Change A3 Built

* Bathroom Layout - Add Showers & note
Kitchenette Sinks.

Revision - 5-11-12

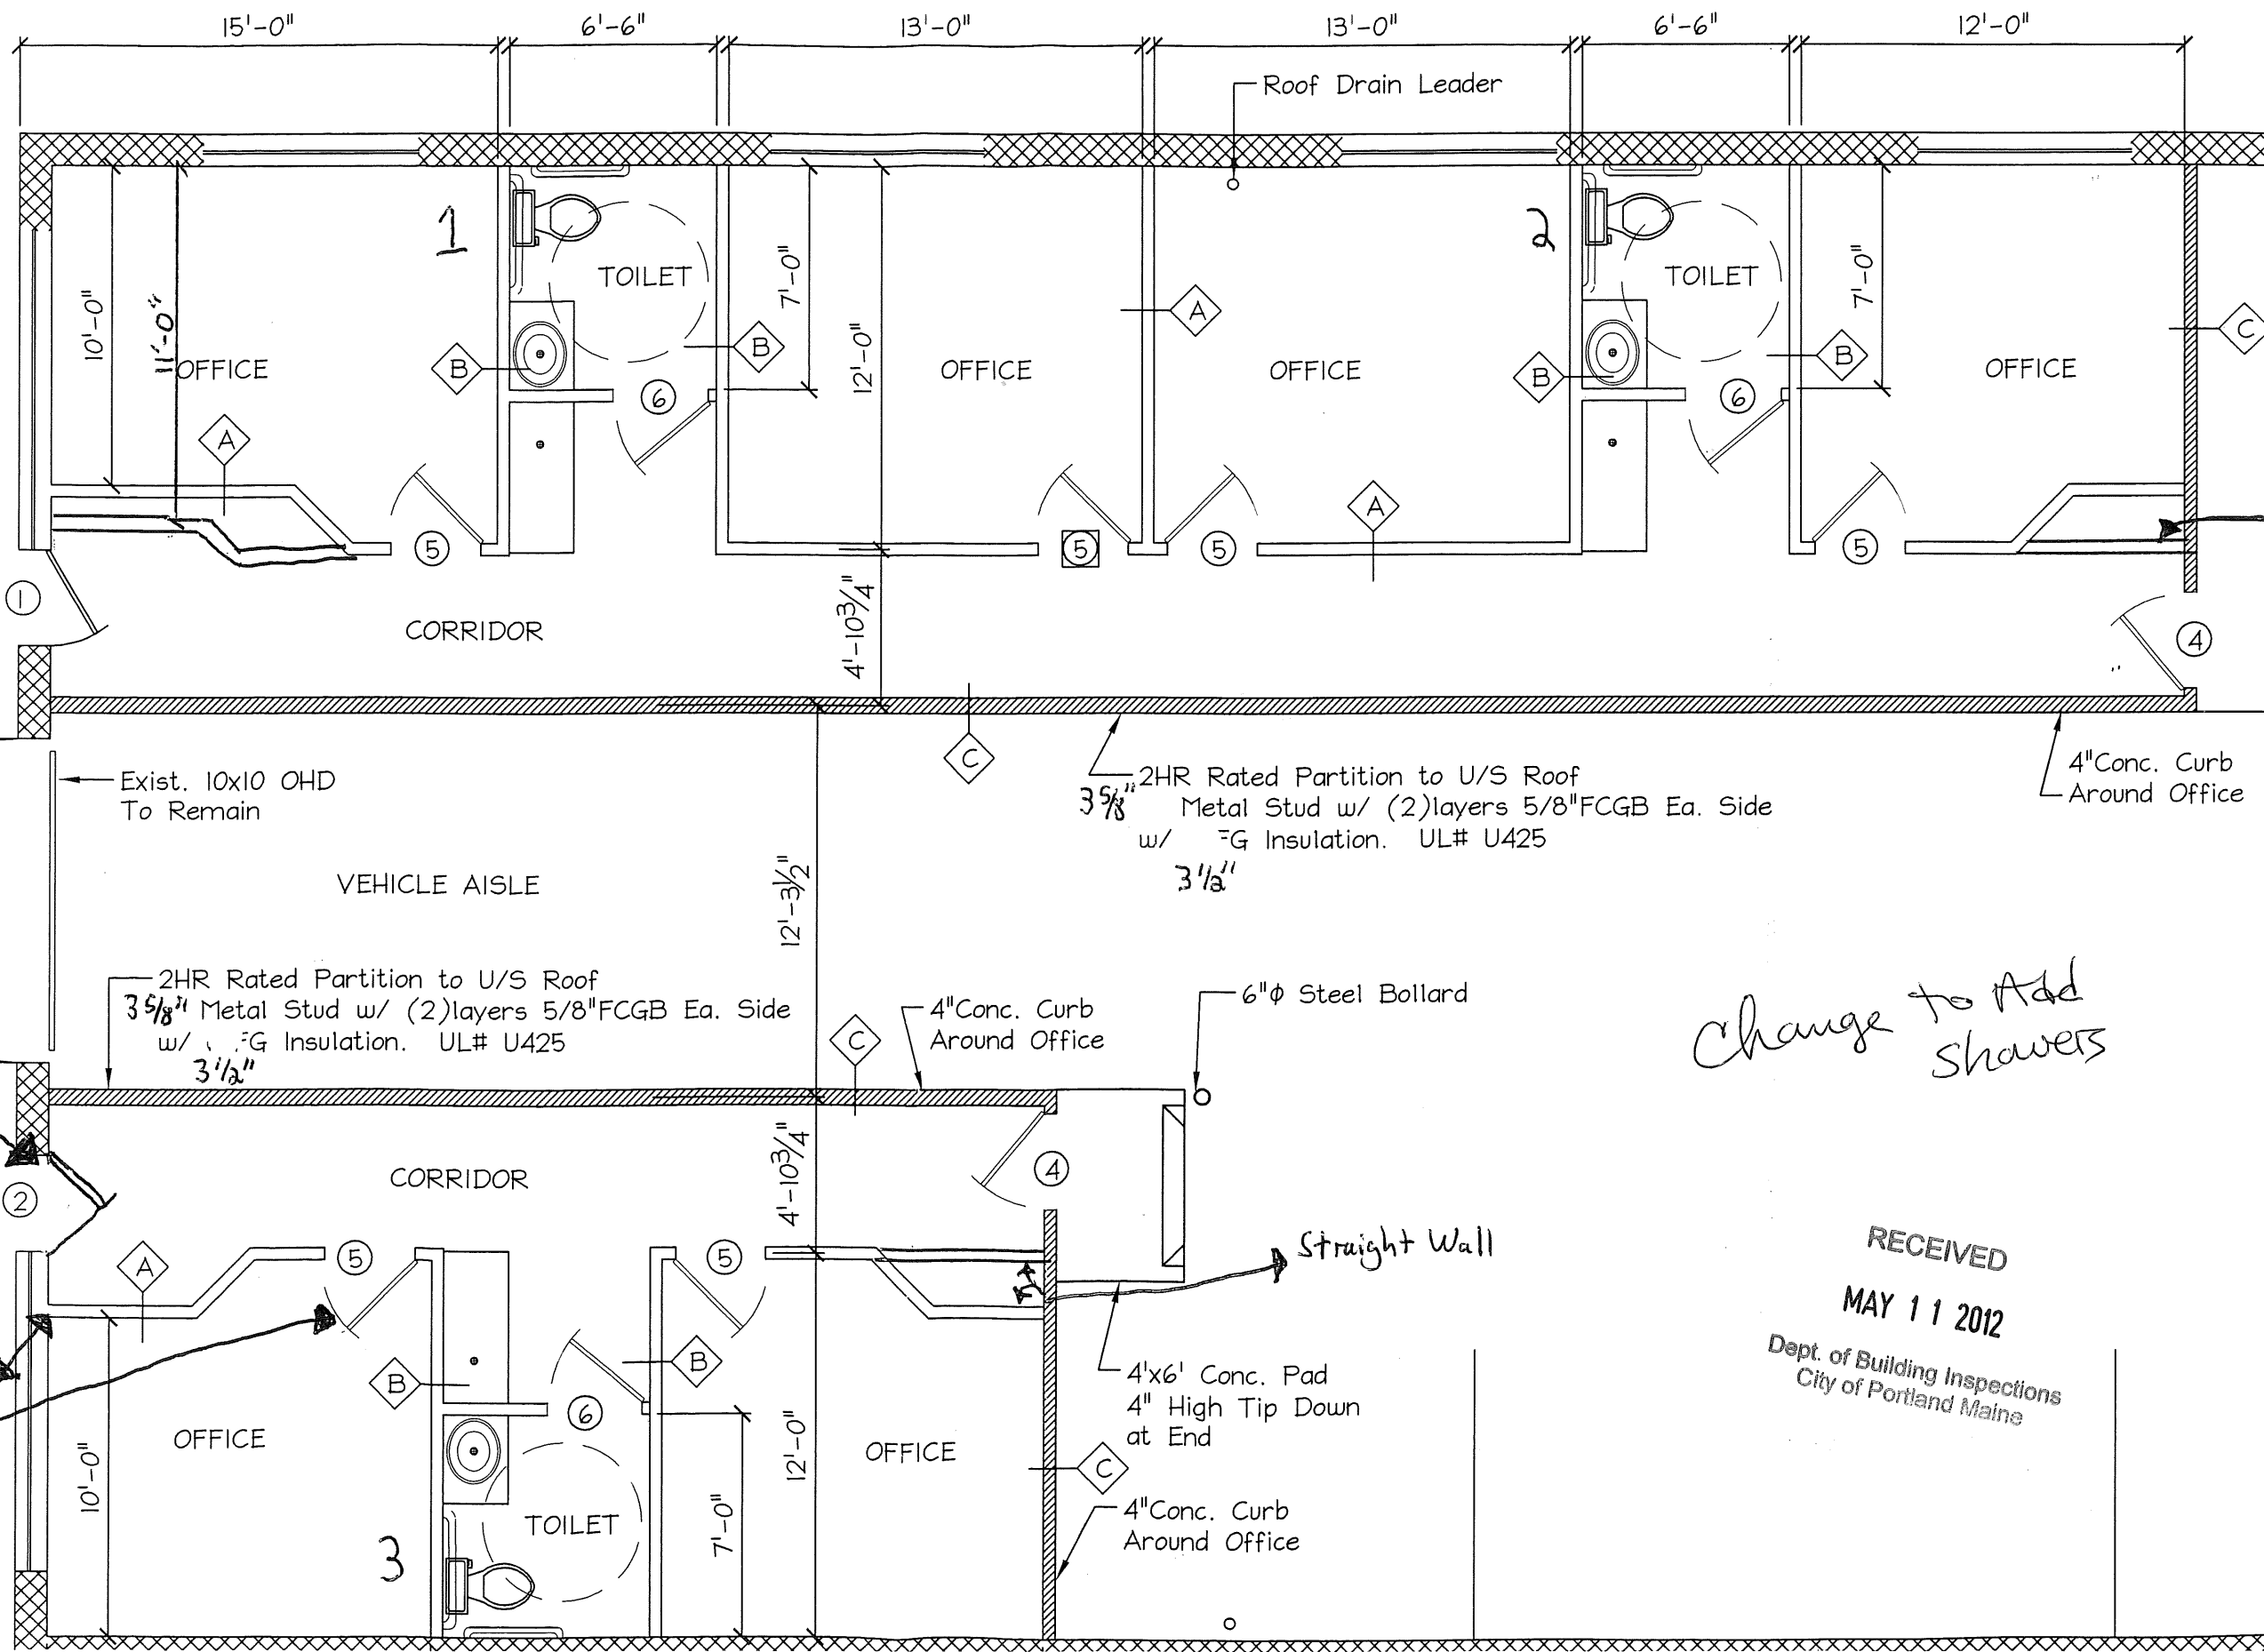
A. Shower Stalls

B. Sinks

Left swing door

Eliminate Wall
& door

Straight Wall

Change to Add
Showers
